ADA Curb Ramp New Construction Inspection Form (Parallel)

23885.56			
North-South Road Name	Project No.	Sheet No.	Intersection No.	East-West Road Name

PARALLEL RAMP (PL)

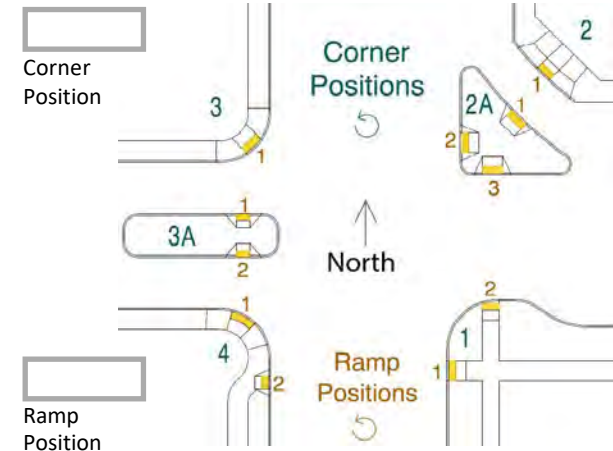
RAMP RUN 3	Pass	Fail
Running Slope 3 9.2 ≤ 8.3% <input type="checkbox"/> > 8.3% <input checked="" type="checkbox"/>		
Length 3 7.5		
Cross Slope 3 <input type="checkbox"/> ≤ 2.0% <input type="checkbox"/> > 2.0% <input type="checkbox"/>

DWS IITD Fails turn space, RR to nowhere
